SERVICE BULLETIN

N° 139-609

ATA 63 - MGB BEARING LOCK-NUT REPLACEMENT

Revision A is issued in order to add MGB P/N 3G6320A00136 S/N AW1, AW2, AW3, AW5, AW10 to Effectivity.

Figure A5

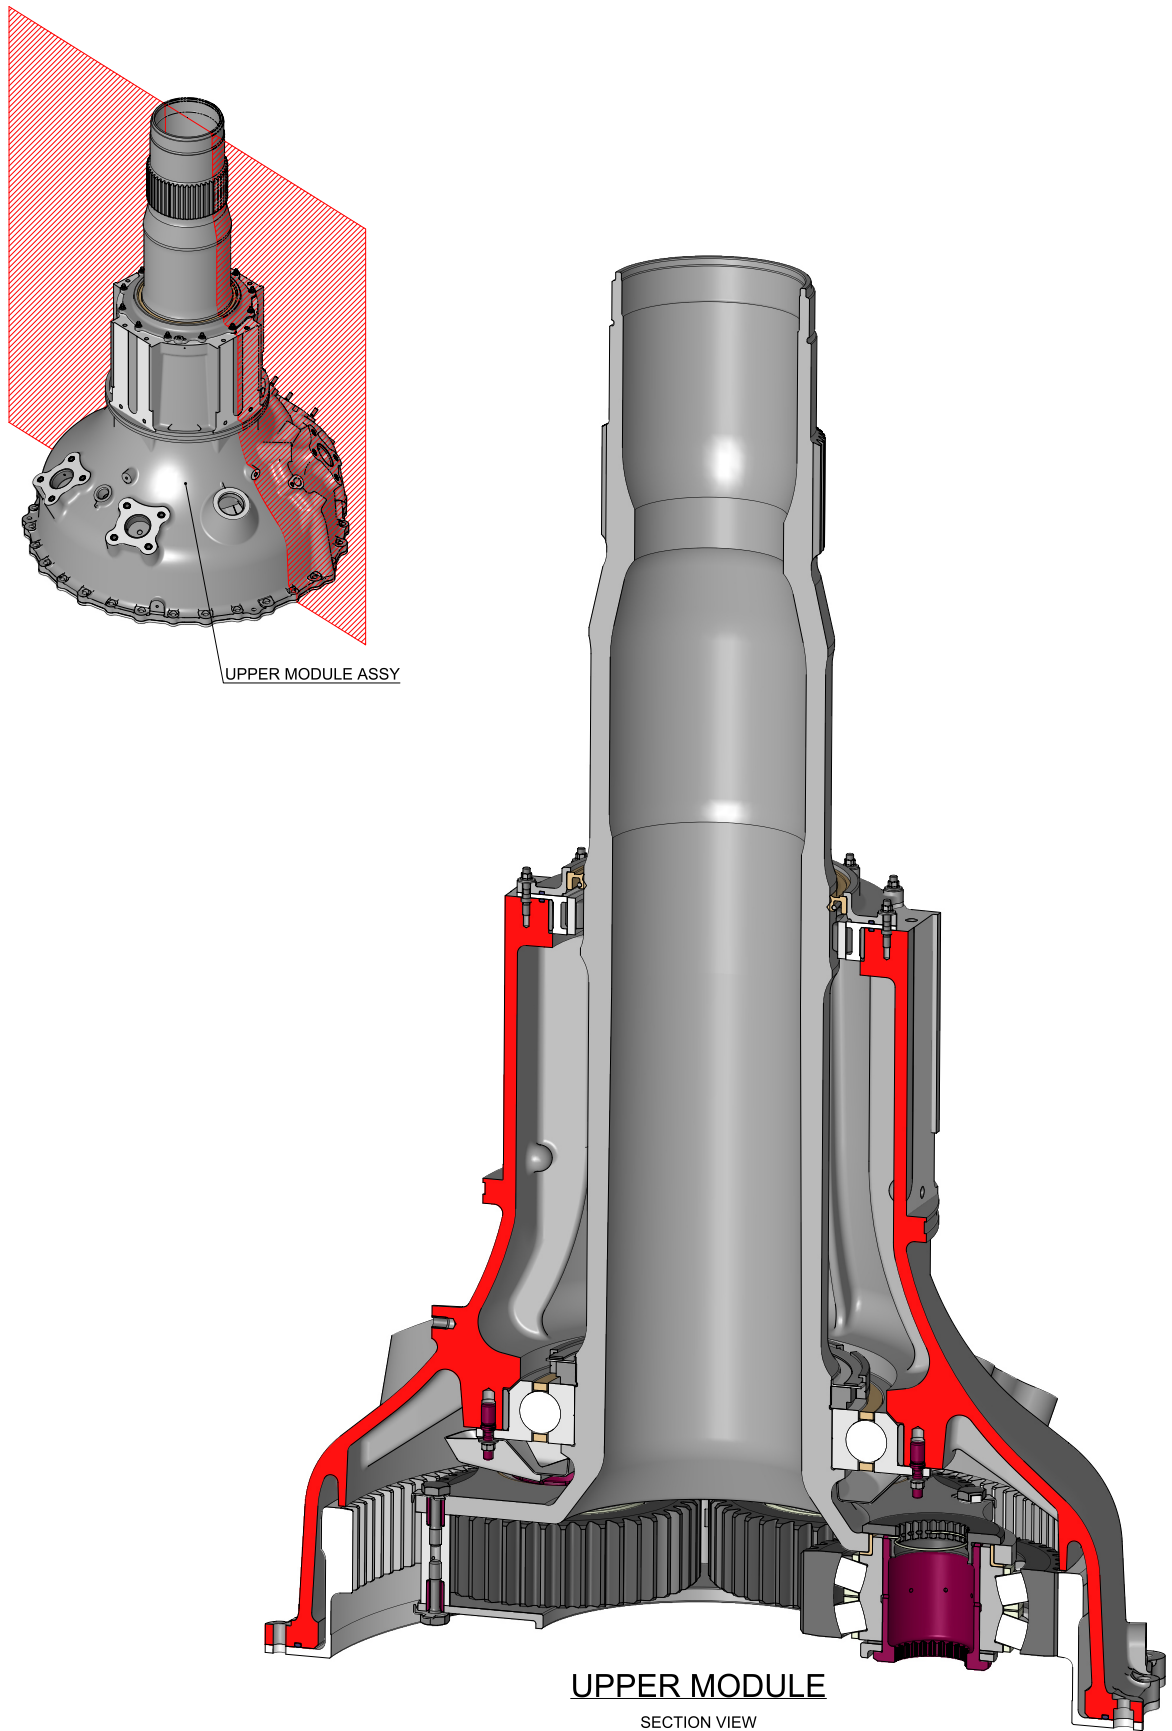
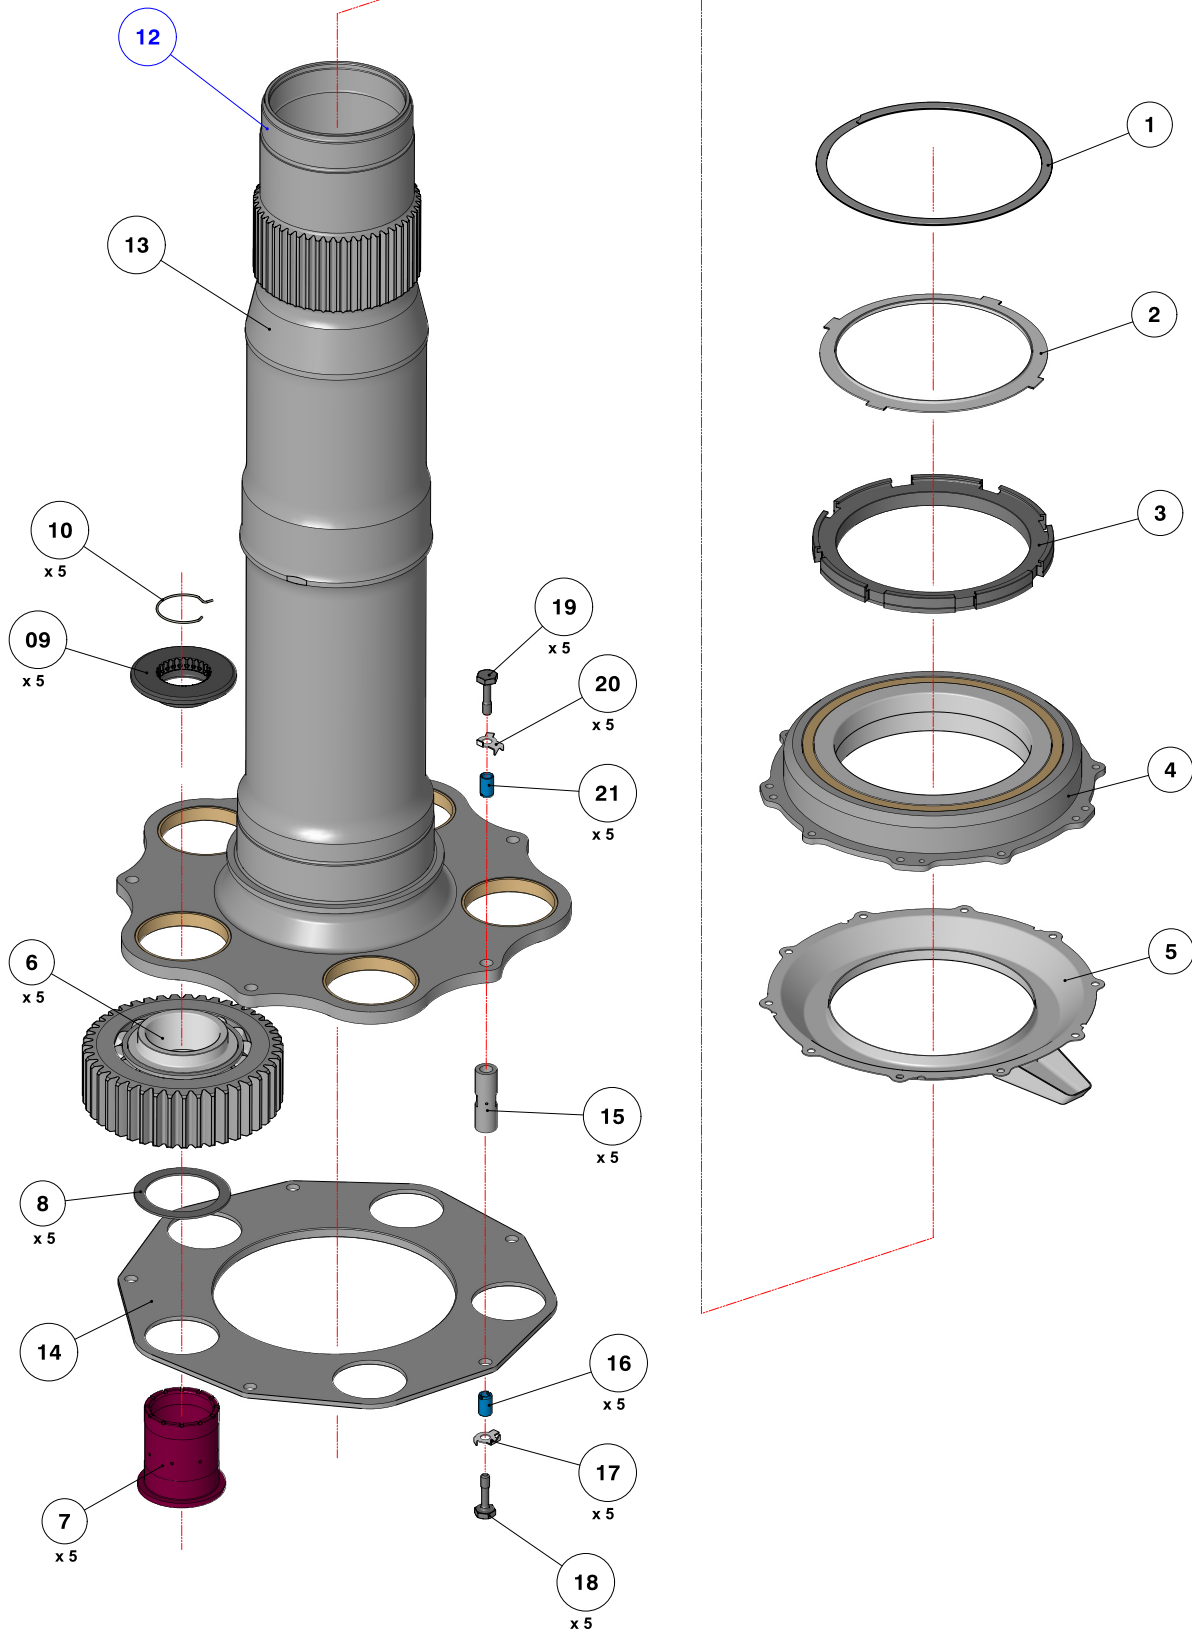
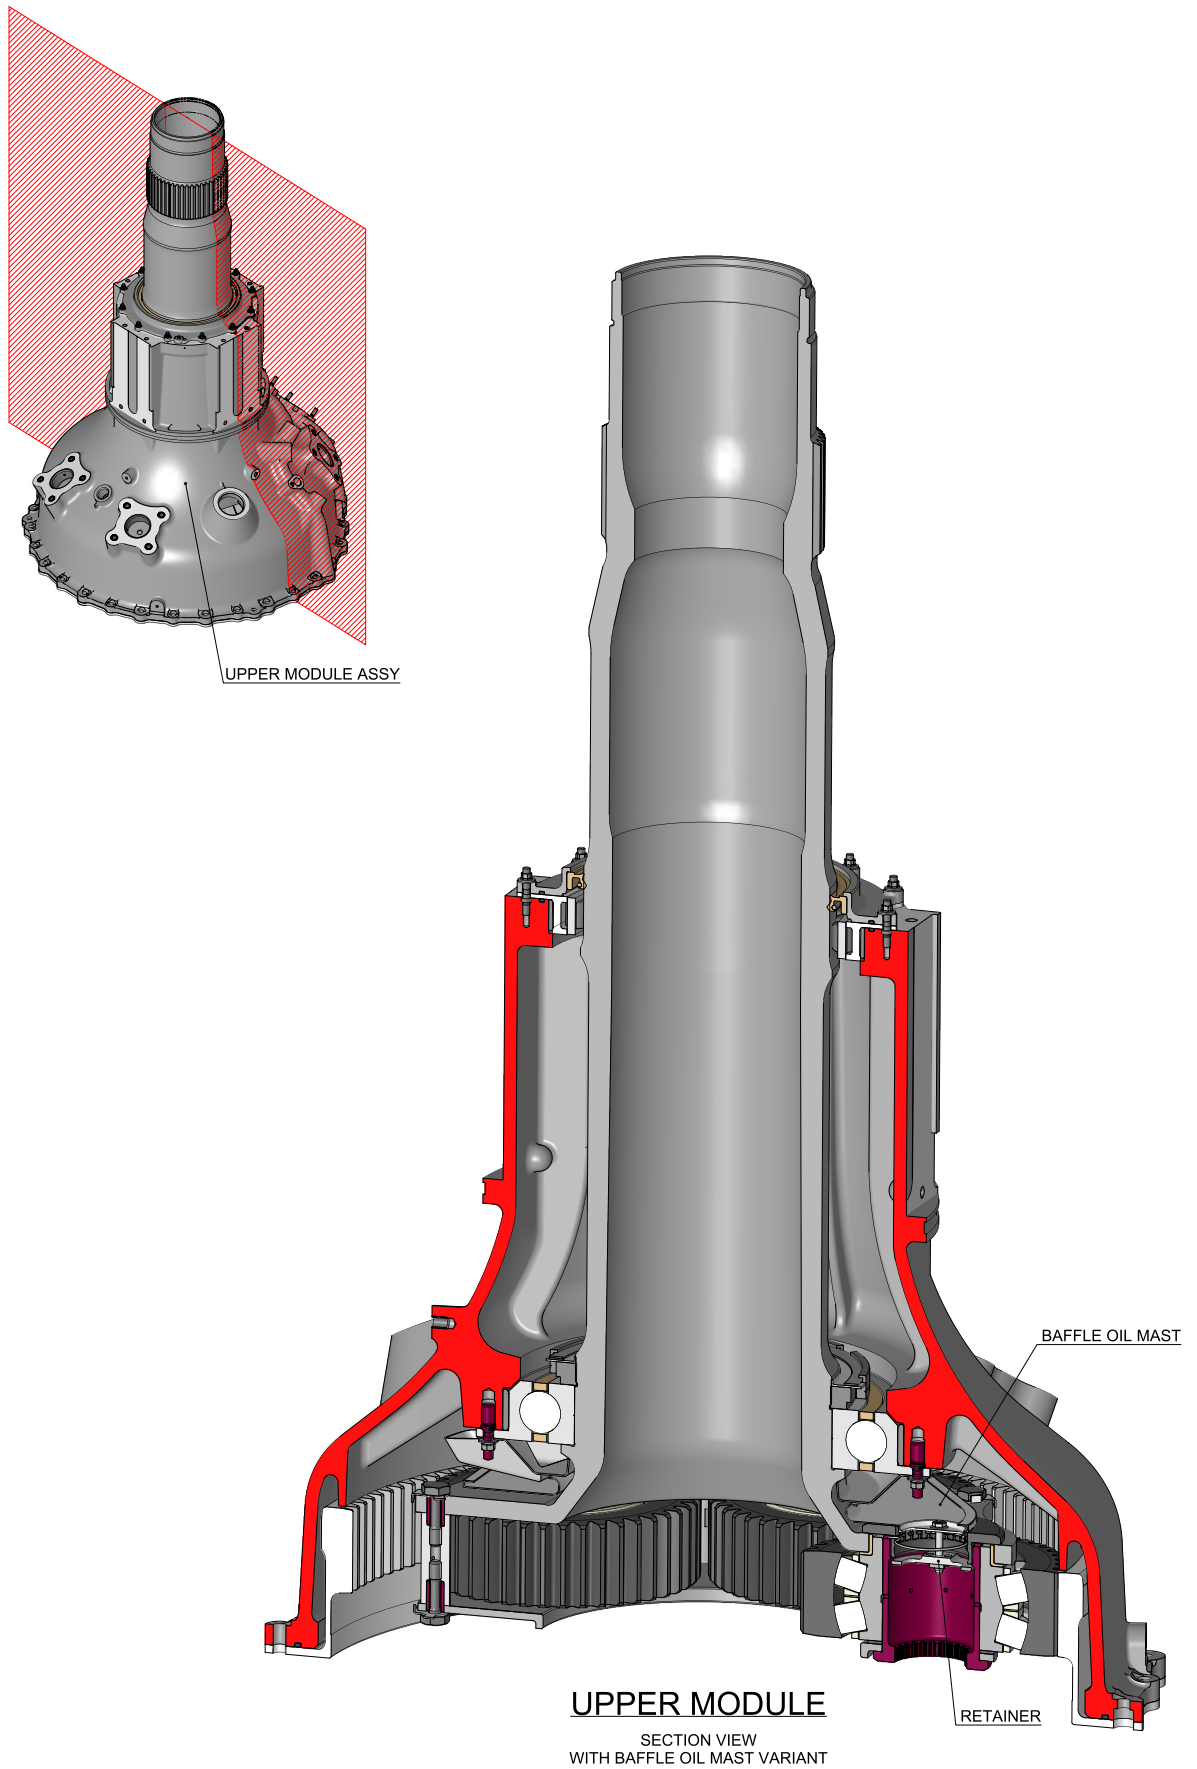
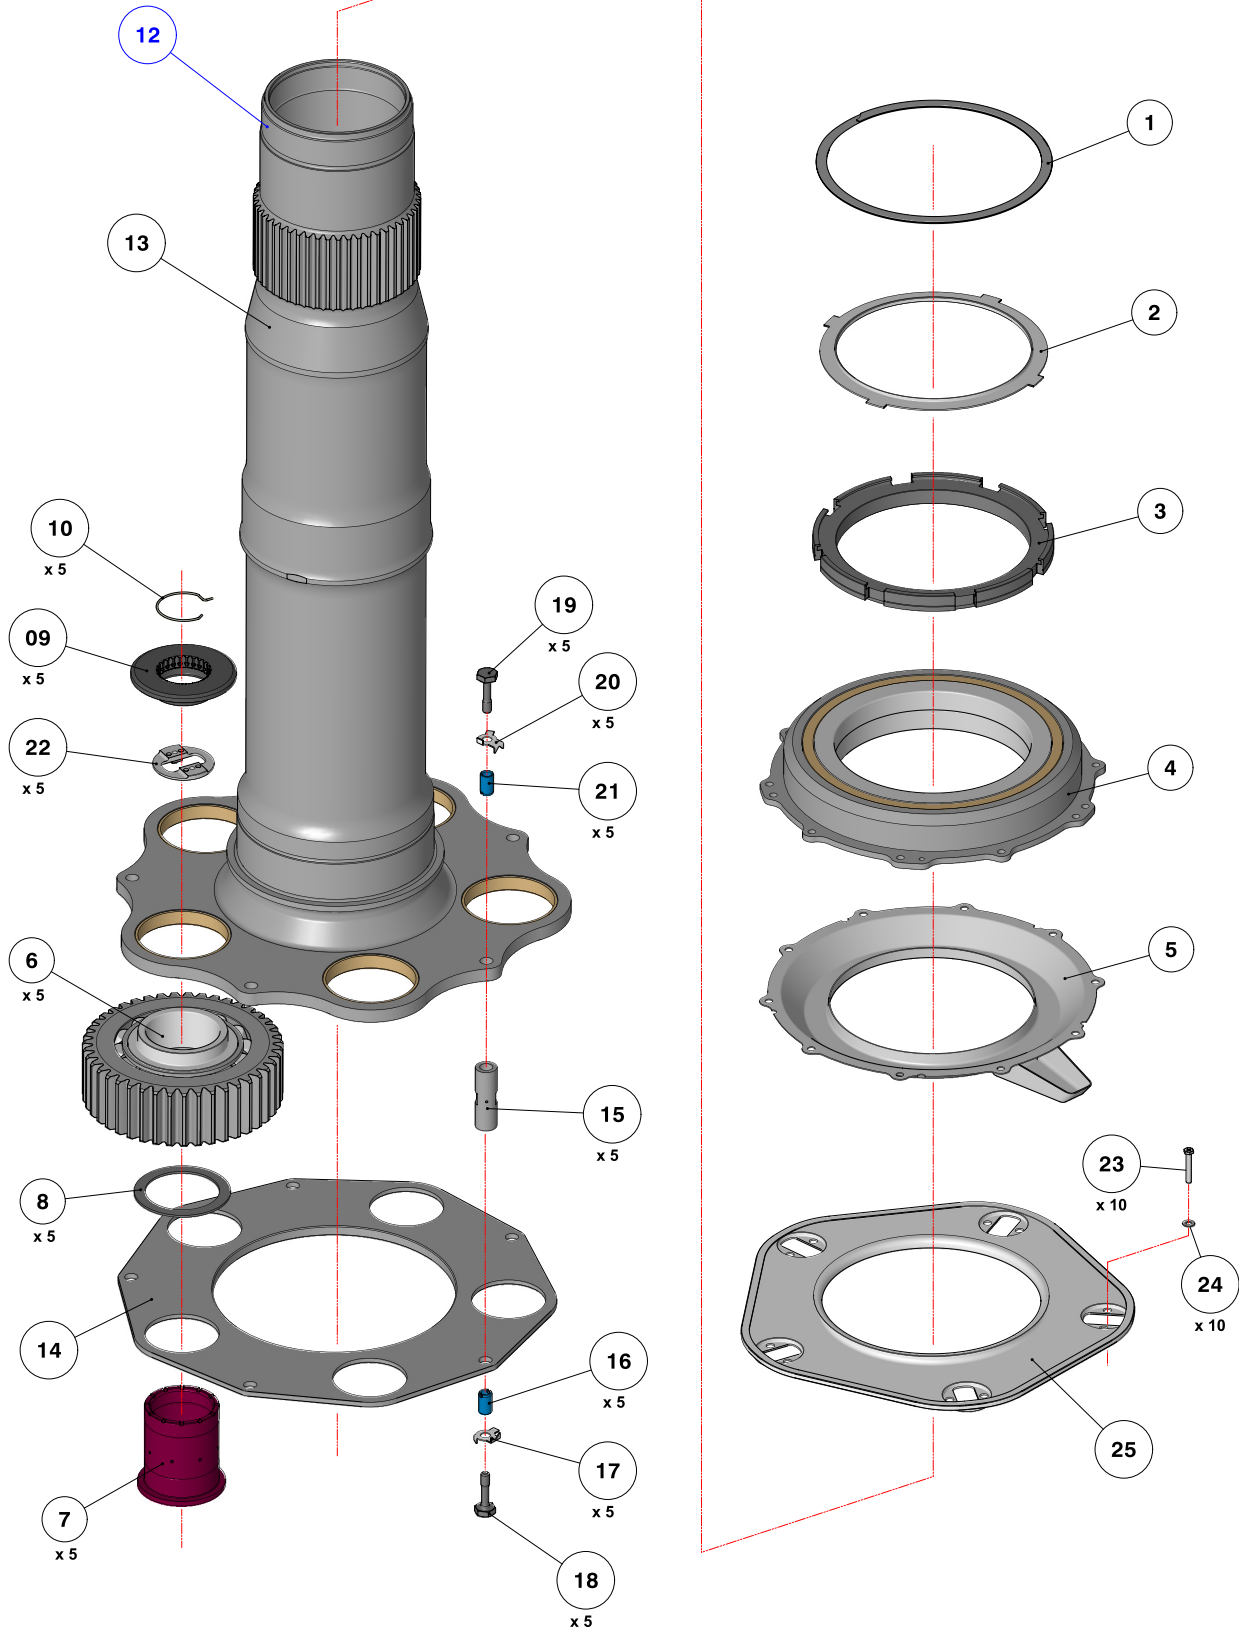
The main difference between the existing nut P/N 3G6320A09151 and the new P/N 3G6320A09152 is related to the increase in the fillet radius between the cylindrical threaded part of the component and the flanged end; this allows reduction of the local peak stress in the critical areas of the nut which were found cracked in service. The new spherical bearing lock nut P/N 3G6320A09152 will be introduced on new built MGB and will be in any case replaced on all MGBs at next Overhaul.

16. With reference to Figures A5 thru A8, remove the ring nuts P/N 3G6320A09151 from the mast-planetary assembly as described in the following procedure:

- 17.3 With reference to Figures A7 and A8, install the retaining plate (22) inside the pin (7).

- 17.4 Install the ring nut (9) on the pin (7). Tighten the ring nut (9) with your hand.
- 17.5 Torque the ring nut (9) with the installation tool P/N 3G6320A07231A023D to the minimum torque value of the interval: 275 thru 294 Nm (203 thru 217 lbf ft).
- 17.6 Install the retaining spring (10) on the ring nut (9). Make sure that the tang of the retaining spring (10) engages the hole in the pin (7) correctly. If not, increase the torque (obey the given tolerance) of the ring nut (9) until you get a positive result.
- 17.7 Repeat steps 17.1 thru 17.6 on the other four ring nut positions until you have installed all the five ring nuts.

- 17.8 With reference to Figures A7 and A8, install the two washers (23) and the two bolts (24) on the planetary assembly (6) to attach the baffle (22) to the flange (14). Apply MIL-S-46163, Type II grade N (Loctite 242) on the screw fillets and torque to 3.2 thru 3.5 Nm.
- 17.9 Install on the top case, in place of the roller bearing (48), the dummy roller bearing n° 10, part of the work trolley P/N 3G6320A00231A188A.
- 17.10 Turn by 180° the top case (50), in order to set up for mast installation.
- 17.11 Install the mast-planetary assembly lifting tool P/N 3G6320A00231A181C on the mast-planetary assembly. Use the attaching items that are parts of the lifting tool.
- 17.12 Using the lifting device, lift the n° 8 rail of the work trolley P/N 3G6320A00231A188A on the lower side of the mast.
- 17.13 Tighten the two bearing aligning pins P/N 3G6320A00231A023D in their seats on
